ENGINE COMPONENTS, INC.

S.I. No.: 04-3

Title: CONTINUING AIRWORTHINESS DATA FOR ECi TITAN™ O-200 CYLINDER ASSEMBLIES WITH CHT BAYONET PROBE BOSS

O-200 Series Cylinder Head With CHT

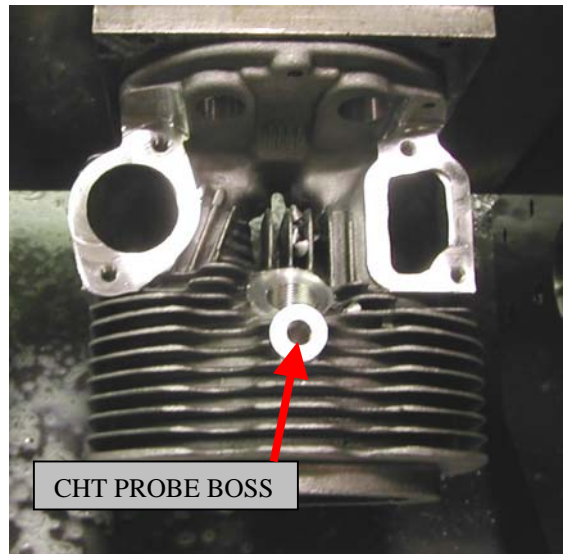
- 4.0 BAYONET PROBE PROVISIONS IN NEW ECi TITAN™ O-200 CYLINDERS:** ECi has revised the casting tooling to provide a Cylinder Heat Temperature (CHT) probe boss below the lower spark plug similar to the probe bosses for other cylinders. This probe boss is machined to accept a probe or receptacle with a 3/8-24 thread.

The new CHT probe boss has been tested under FAA Project PM7600SC-E to verify that there is no degradation of the cooling and to compare the temperatures measured at this probe with the spark plug locations (washer type thermocouple under the spark plug). The testing accomplished revealed that the new CHT boss had insignificant (immeasurable) effect on cooling. Additionally, calibrated probe type thermocouples recorded temperatures of 20 to 25 °F lower than the lower spark plug, and almost the same amount hotter than the top spark plug.

- 5.0 NEW MAXIMUM CYLINDER TEMPERATURES:** Because the probe type thermocouples measure between 20 and 25 °F lower temperatures than temperatures measured at the lower spark plug, ECi recommends that the maximum operating temperature when using thermocouples installed in this location should be maintained below 500 °F. ECi further recommends that cruise temperatures be maintained below 415 °F for longer cylinder life.
